Iowa Department of Transportation  
Office of Contracts                      Date

<b>B.O.</b>	<b>Proposal ID</b>	<b>Proposal Work Type</b>	<b>County</b>	<b>Project Number</b>	<b>Addendum</b>
004	13-C013-090	BRIDGE DECK OVERLAY	CALHOUN	BHS-C013(90)--63-13	20DEC004A01

CALHOUN COUNTY BRIDGE DECK OVERLAY

PROJECT NO. BHS-C013(90)--63-13

EXISTING BRIDGE RAIL/CURB REMOVAL DETAIL

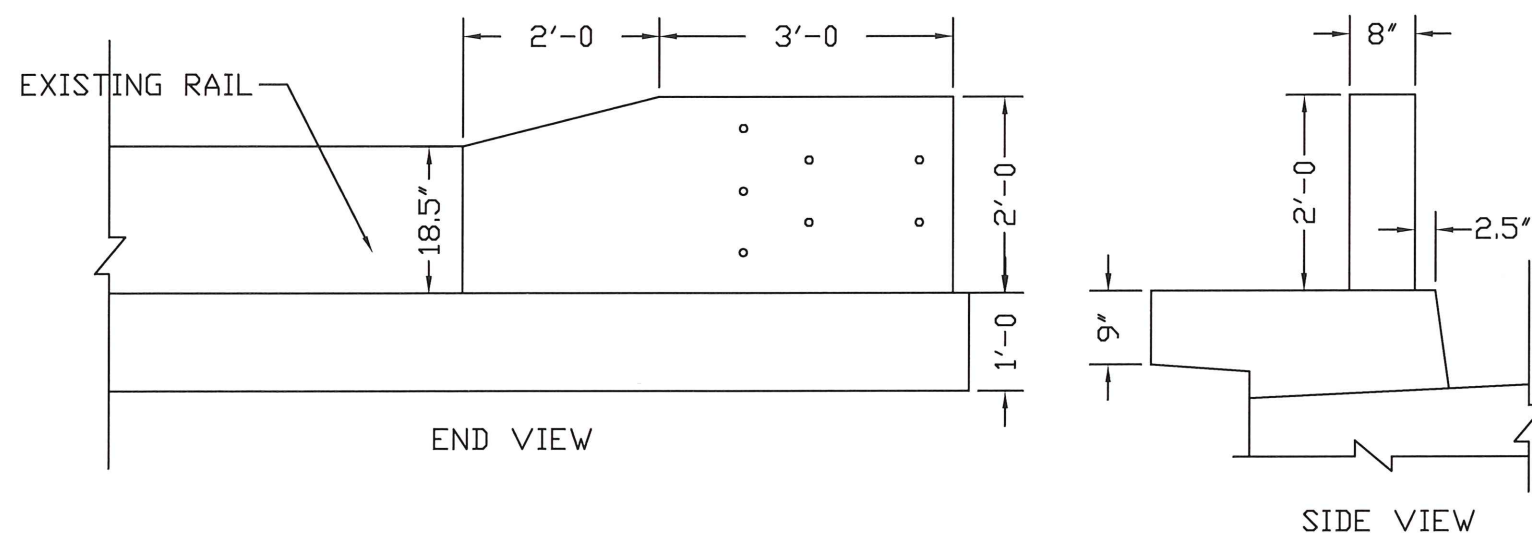
- 16. THIS ITEM INCLUDES ALL LABOR AND MATERIALS TO REMOVE THE SECTION OF CONCRETE END RAIL AND CURB AS SHOWN IN THE DETAILS ON SHEET 4. THIS INCLUDES, BUT IS NOT LIMITED TO, SAWING, CHIPPING, PROTECTING AND TYING INTO THE EXISTING REINFORCING STEEL AS REQUIRED. THIS ALSO INCLUDES PROVIDING THE NECESSARY BOLT HOLES AND ANY OTHER MISCELLANEOUS ITEMS TO ALLOW CONNECTION TO THE NEW GUARDRAIL END CONNECTION(BA-202) TO BE MADE.
